NUMBER: [Single] 1/71
SUBJECT: Oil Return Tube
MODELS: B25T/B25SS
DATE: 3/12/71

SERVICE BULLETIN

O I L R E T U R N T U B E

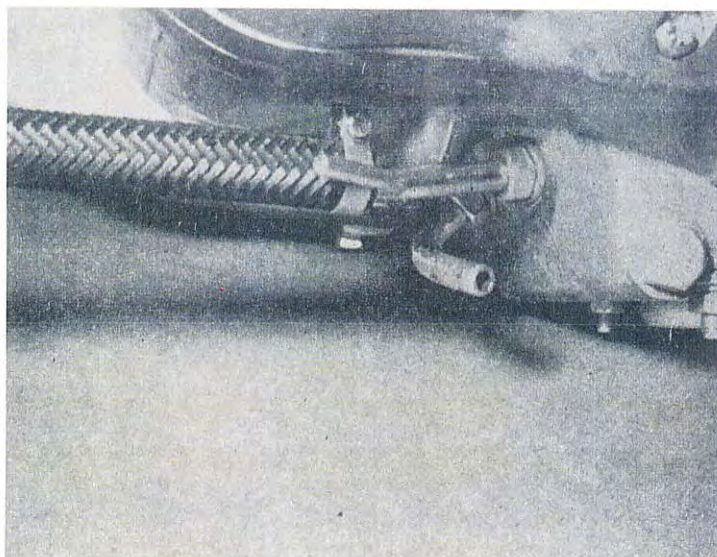
It is necessary to reposition the oil return hose (see below) on all 1971 B25T/B25SS motorcycles prior to delivery.

1. Loosen the hose clamp and move the oil return hose forward until it butts against the rocker feed pipe.
2. Position the hose clamp with the screw at top and tighten the clamp.

All future-production units will contain the oil return pipe with an increased length of one inch.

B R A K E R E T U R N S P R I N G

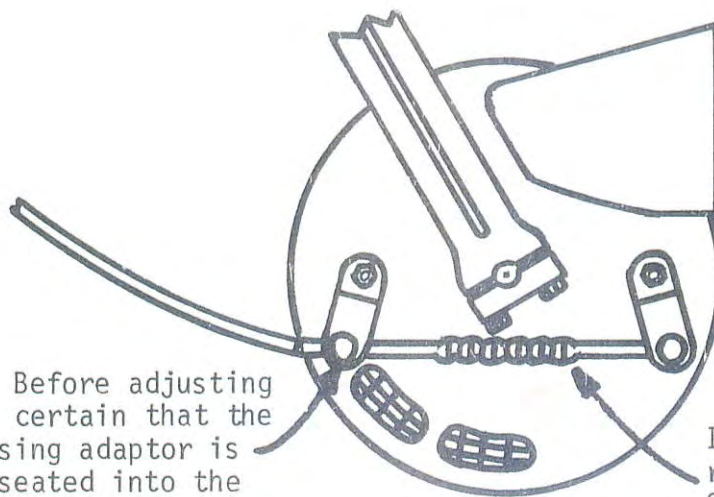
An engineering change has been made to improve the front brake return mechanism on all 1971 models fitted with the new-type double leading shoe front brake. A rubber gaiter was originally fitted on the cable between the two brake arms; this gaiter is to be removed and a spring [Part #37-4014] fitted in its place.

PLEASE REMOVE THE RUBBER GAITER AND INSTALL THE SPRING ON ALL 1971 MODELS SOLD BY YOUR DEALERSHIP - THE SPRING WILL BE FURNISHED FREE FOR REPLACEMENT PURPOSES.

INSTALLATION: Remove rubber gaiter--install Spring #37-4014

BATTERY INSTALLATION

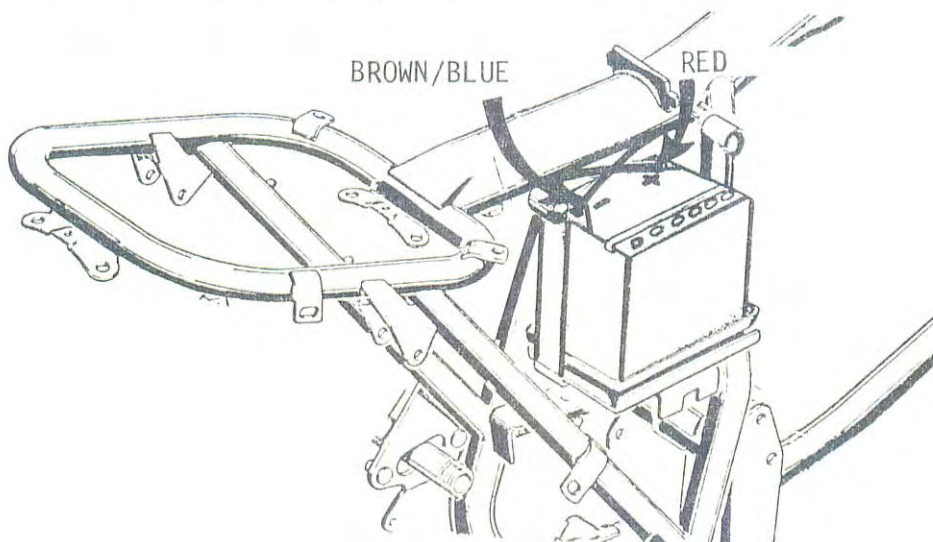
There have been isolated cases of electrical failures on B25's due to improperly installed batteries. The battery should be installed as explained below or the terminals may contact the righthand side cover and short out the electrical system:

1. Position the battery in the carrier as shown below, with the terminals located adjacent to the inside of the motorcycle.

MAKE SURE THE BATTERY FILL PORTS ARE POSITIONED TO THE OUTSIDE OF THE UNIT, NEAR THE RIGHTHAND SIDE COVER, FOR EASY SERVICING.

2. Run both positive (+) and negative (-) terminal wires as near parallel to the inside of the battery case as possible.

ROTOR TIMING MARKS

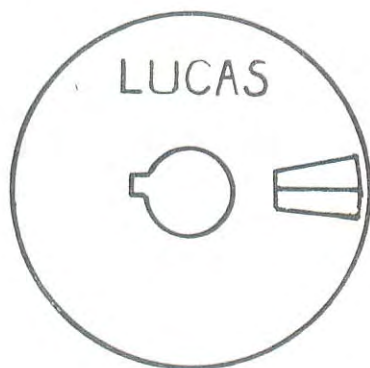
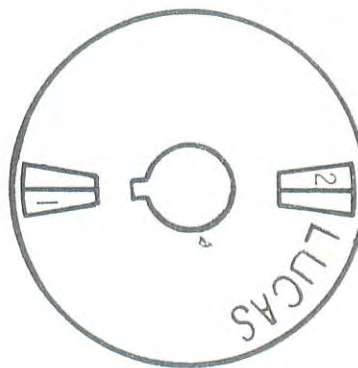
LUCAS alternator rotors are now being supplied with two numbered timing marks cast in the surface (as shown below). The No. 1 timing mark is always nearest the keyway, and the No. 2 timing mark is 180° opposite.

BOTH THE NO. 1 AND NO. 2 TIMING MARKS ARE USED WHEN TIMING THE DOUBLE OVERHEAD CAM, TWIN-CYLINDER, 350CC ENGINE -- ALL OTHER ENGINES EXCEPT THE THREE-CYLINDER 750CC ARE TIMED TO THE NO. 2 TIMING MARK.

A few motorcycles were delivered incorporating rotors containing two timing marks -- but without the number identification. The No. 2 timing mark is still located opposite the keyway, or adjacent to the embossed "LUCAS" (see "NEW" below). This timing mark is used as one of the timing marks for the 350cc engine and for all other engines except the 750cc.

B50 MX EXHAUST SYSTEM

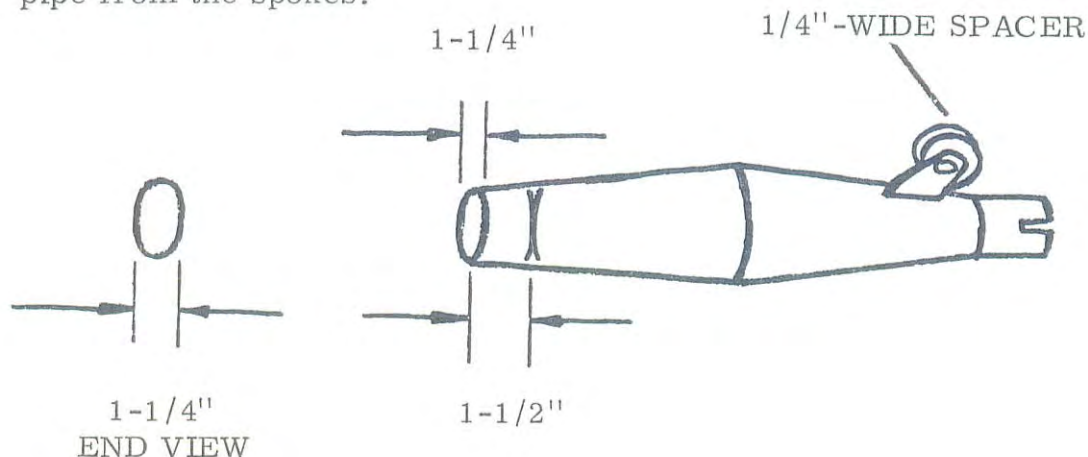
CAUTION: When the rear suspension is compressed, the end of of the exhaust pipe will contact the rear wheel spokes. Correct this interference problem by reshaping the end of the exhaust pipe to the dimension shown below and by installing a 1/4-inch-thick spacer on the mounting bracket to separate the exhaust pipe from the spokes.

CRANKSHAFT BALANCE FACTOR

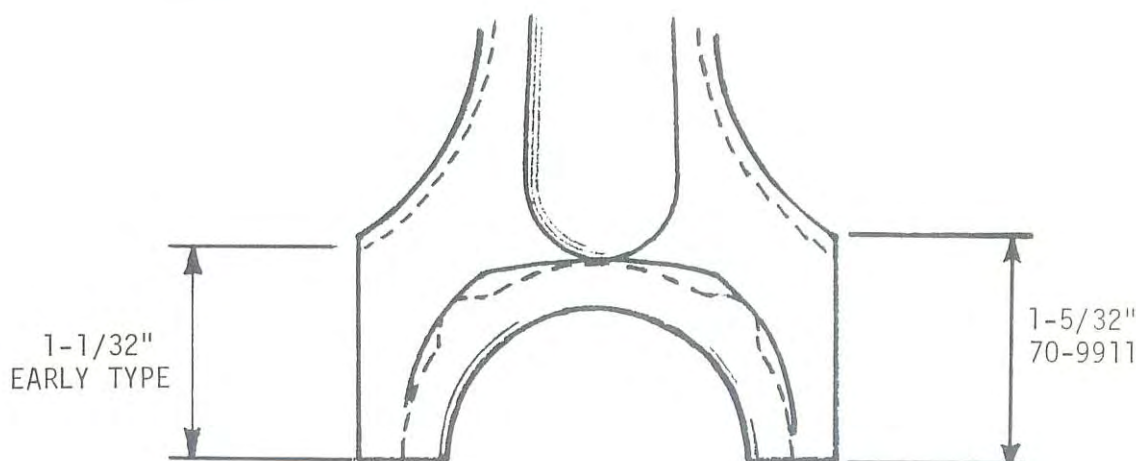
BEFORE 1971: The crankshaft balance factor on all B25's produced prior to, and including, 1970 is 58%; the balance weight value is 15 oz. plus 7.97 grams. The part number of the balance weight is 61-3809.

1971 & SUBSEQUENT UNITS: The balance factor for 1971 units is 54%; the weight for balancing the crankshaft is 18 oz. plus 5.3 grams. The part number of the balance weight is 61-6124.

IDENTIFYING 1971 COMPONENTS: The 54% balance factor applies only to the crankshaft that accepts Connecting Rod #70-9911. Connecting Rod #70-9911 may be identified by the big-end cap bolts, which are 2-1/2" UNF measured from beneath the bolt head. Another identifying characteristic is the longer big-end boss, which is 1/8" larger than the older part, as shown below. (The profile of the early connecting rod is represented by a broken line.)

CONNECTING ROD #70-9911 WILL NOT FIT PRE-1971 CRANKSHAFTS

FRONT BRAKE CABLE STOPLIGHT SWITCH MODIFICATION

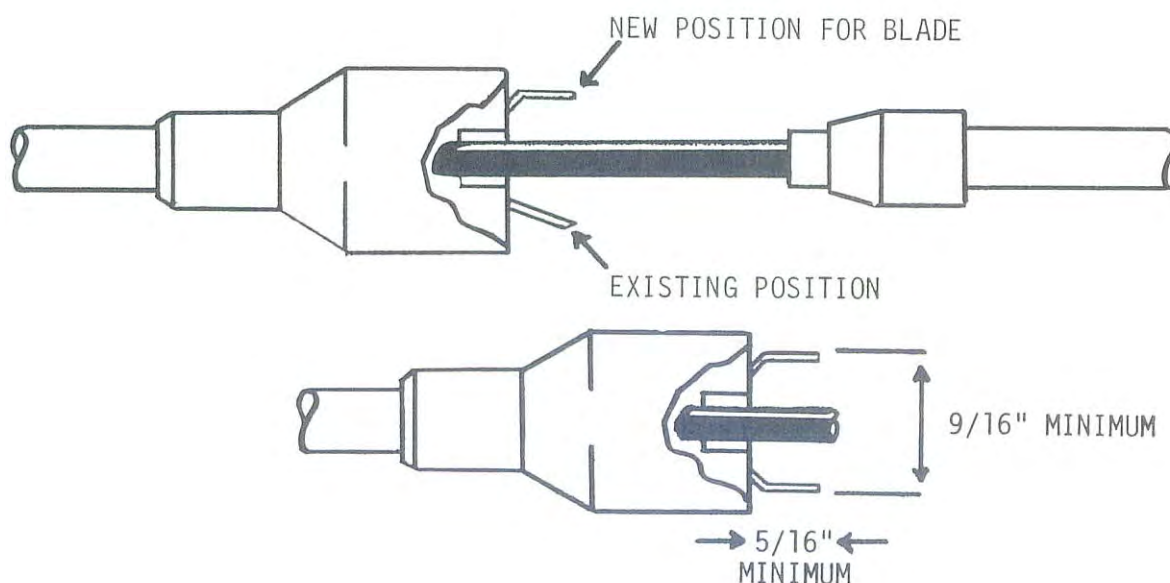
The Lucar blades on the front brake cable stoplight switch occasionally wear through the plastic sleeving covering the blades. With insulation destroyed, the blades contact the brake cable ferrule and short out the electrical system. Modify the switch blades (see below) to prevent this potential malfunction:

1. Remove front brake cable from handlebar lever.
2. Remove front brake stop switch cover.
3. Disconnect electrical leads.
4. Using needle-nose pliers, shape blades to configuration illustrated, making sure that blades are separated by, at least, $9/16$ " after final forming.
5. Reconnect electrical leads -- install plastic sleeves over blades, brake stop switch cover, and brake cable on handlebar lever.

ZENER DIODE INSTALLATION (Heat Transfer Compounds)

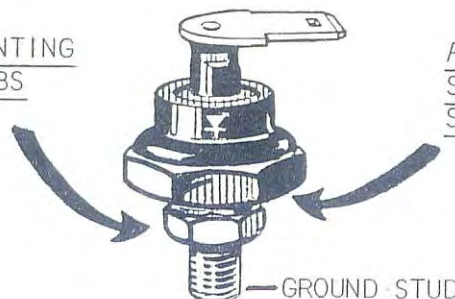
Clean all corrosion, rust, scale, and hydrocarbons from Zener diode mounting area. Apply a thin coating of silicone compound to mounting surface (stud side) of diode before mounting on air cleaner assembly or, on pre-1971 models, before mounting on finned heat sink assembly.

TIGHTEN DIODE MOUNTING
NUT TO 22-28 IN/LBS
TORQUE.

APPLY COMPOUND THIS
SURFACE AND MATING
SURFACE.

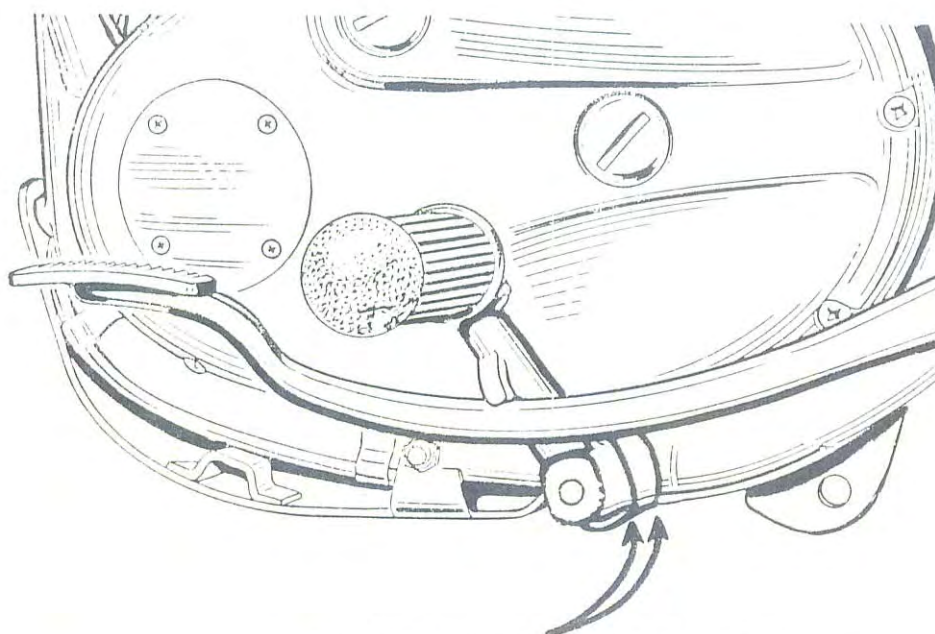
Installation on Early Models: The new bolt can be fitted to early models by simply drilling the frame lugs and the footrest hangers to 29/64 inch. This modification can be carried out with a 1/2-inch drill motor and the proper drill bit. (See Below)

AUTO ADVANCE FAILURES

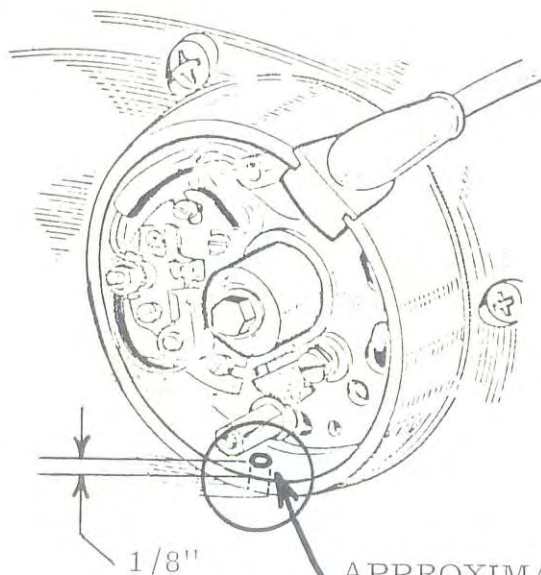
Lack of attention to the contact breaker and auto-advance mechanism can lead to the corrosion of these items due to the accumulation of condensation.

APPROXIMATELY 1/8 INCH FROM EDGE
--DRILL 1/16-INCH DIAMETER HOLE AT
BOTTOM OF CONTACT BREAKER CAVITY.
